# New Ashok Nagar Forum

**Subject: Review of MPD 2021 pertaining to Road Network in E21 East Zone and covering: Noida Link Road - Mayur Vihar DND Flyover - New Ashok Nagar Metro Station- IFC Ghazipur and NH24 Suggestions thereof**

**Review of MPD 2021 pertaining to  
Road Network in E21 East Zone and covering:  
Noida Link Road – Mayur Vihar DND Flyover – New Ashok  
Nagar Metro Station– IFC Ghazipur and NH24  
Suggestions thereof**

**Missing Detail in March 2010 Map**

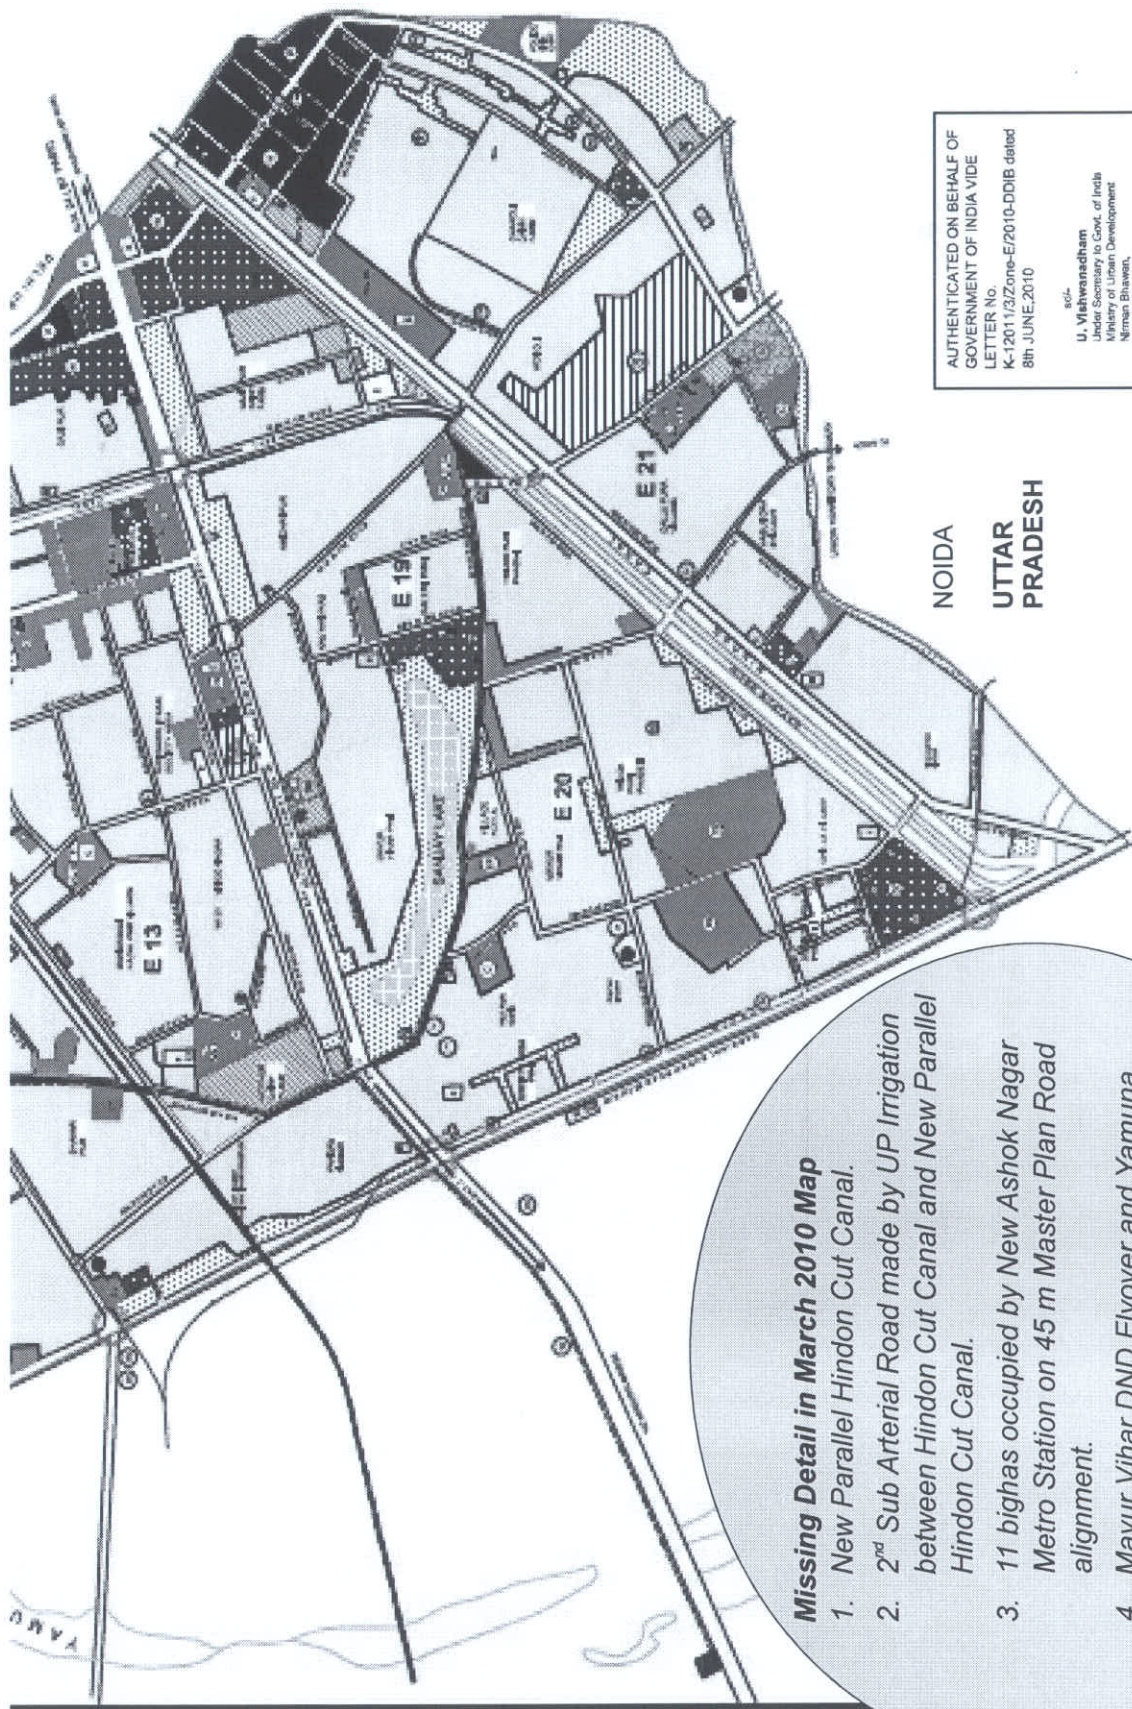
1. New Parallel Hindon Cut Canal.
2. 2<sup>nd</sup> Sub Arterial Road made by UP Irrigation between Hindon Cut Canal and New Parallel Hindon Cut Canal.
3. 11 bighas occupied by New Ashok Nagar Metro Station on 45 m Master Plan Road alignment.
4. Mayur Vihar DND Flyover and Yamuna Bridge.
